6.0 ADMINISTRATIVE CONTROLS

Figure 6.2-1 Facility Organization -- St. Lucie Plant, Unit 1

SAFETY EVALUATION

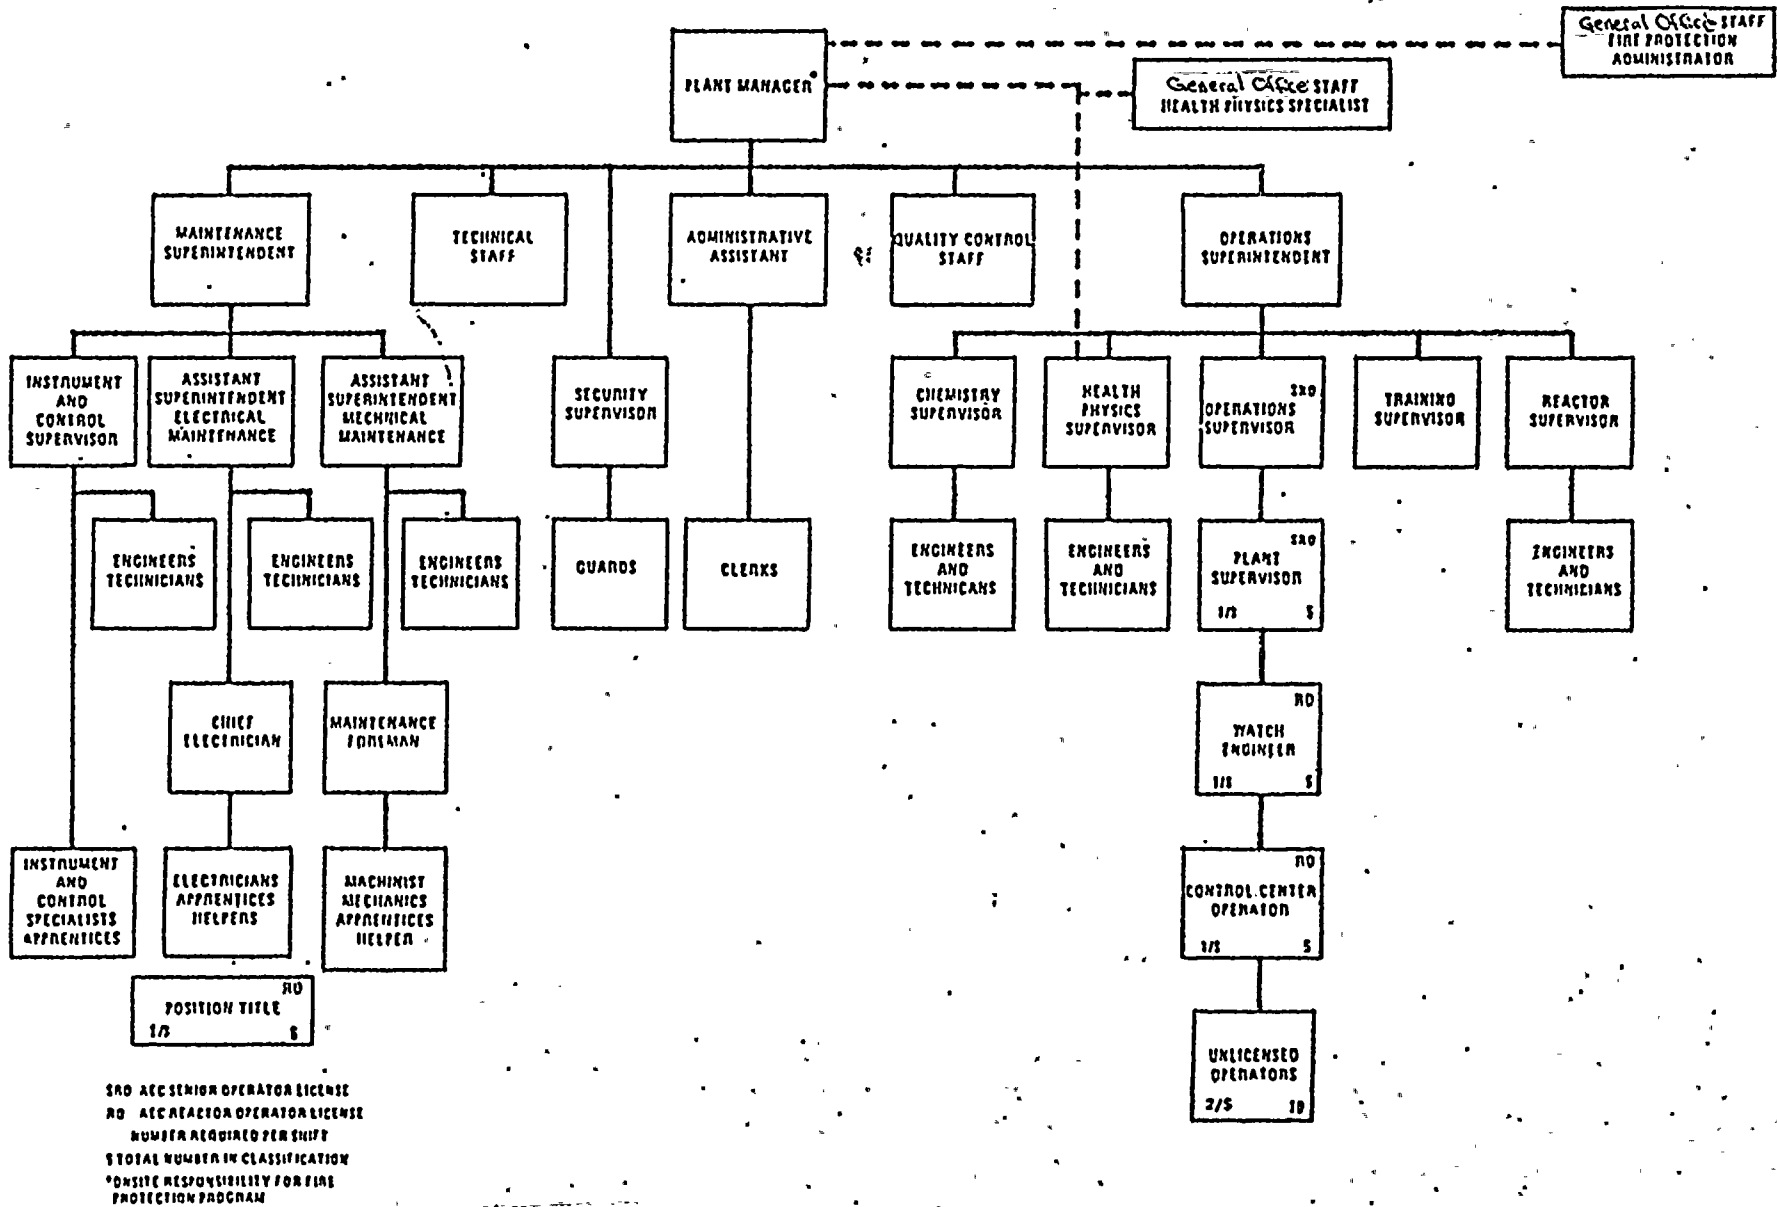
There are no safety related effects connected with the removal of the offsite management and technical support description and organization charts from the Technical Specifications. The purpose of including these descriptions is for general information of the corporate structure to those in possession of the Technical Specifications. However, the same information is also contained in the Florida Power & Light Company Topical Quality Assurance report (FPLTQAR).

The FPLTQAR is required to be updated to reflect all changes to the organization which affect quality within 30 days by letter and one year by amendment. It is our opinion that duplication of material between the two documents is unnecessary and that processing the same change twice is an unneeded burden on the time and manpower resources of both FPL and the NRC. Should the need arise for information on the organization, the FPLTQAR will be available to the same people who previously would have had the organizational description in the Technical Specifications.

6.2.1 The offsite organization for facility management and technical support shall be shown in Appendix A of the Florida Power & Light Company Topical Quality Assurance Report.

6.2.2 The Facility organization shall be as shown on Figure 6.2-1 and:
